**SAFETY
RECALL**

SR24-11

DATE :	March 2024	SECTION :	14 STEERING
SUBJECT:	STEERING JOINT REPLACEMENT

STEERING JOINT REPLACEMENT

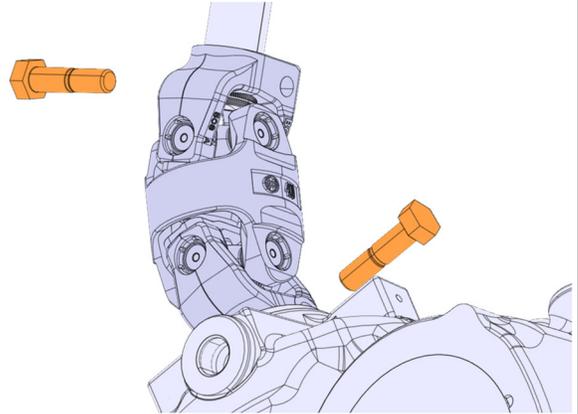
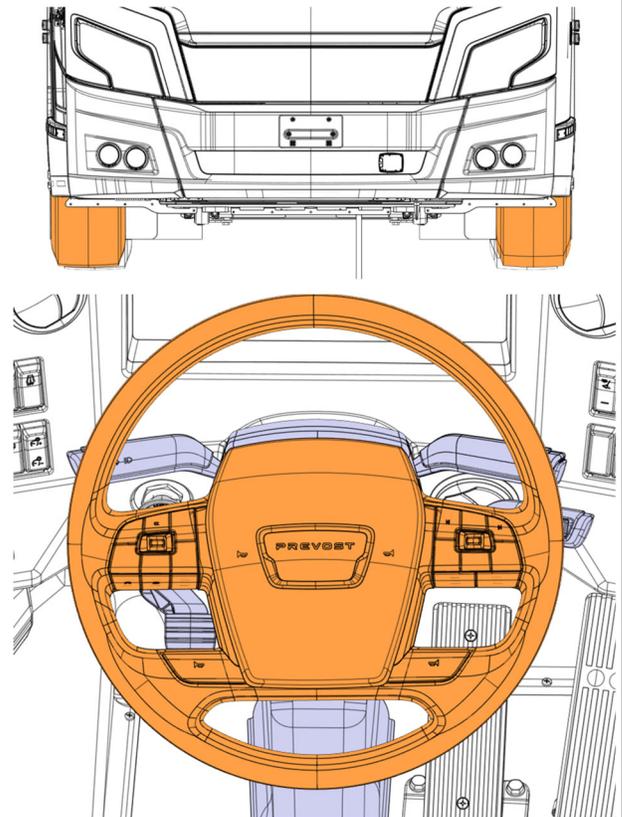
4. Remove bolts 660072 and discard.

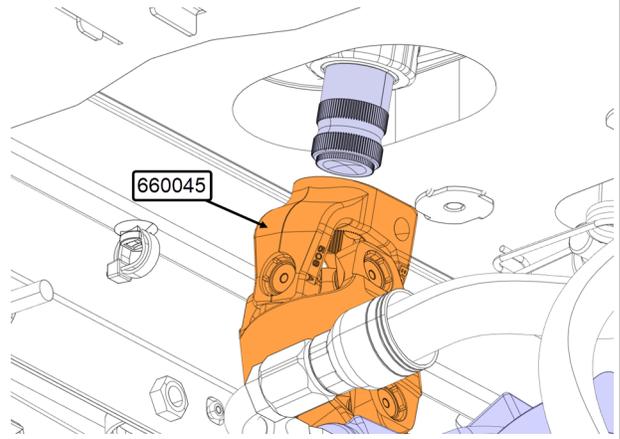
8. Install the new joint 660045 on the steering column shaft.

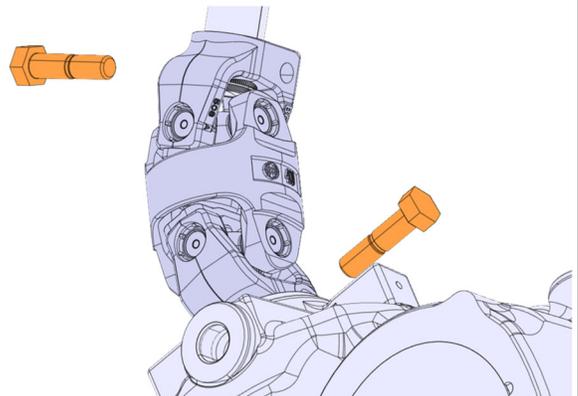
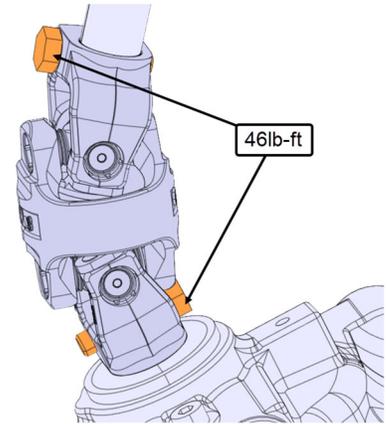
10. Install new bolts 660072.

11. Torque to 46lb-ft.

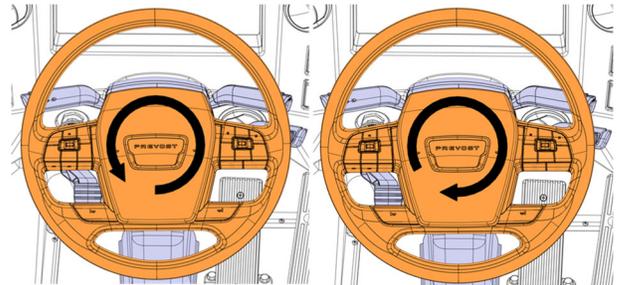
12. Apply torque seal 685353 on each bolts.

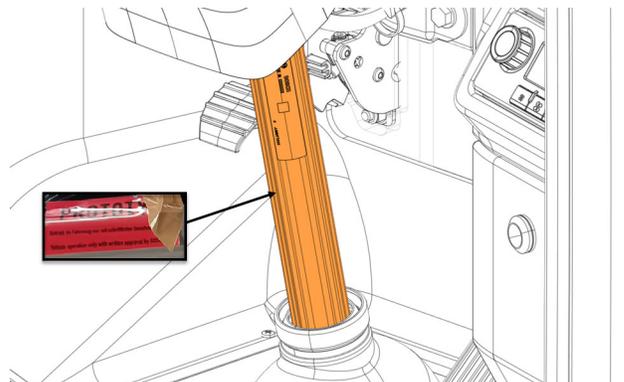
3. Verify if you have the red sticker
"PROTOTYPE".
If yes, remove it.
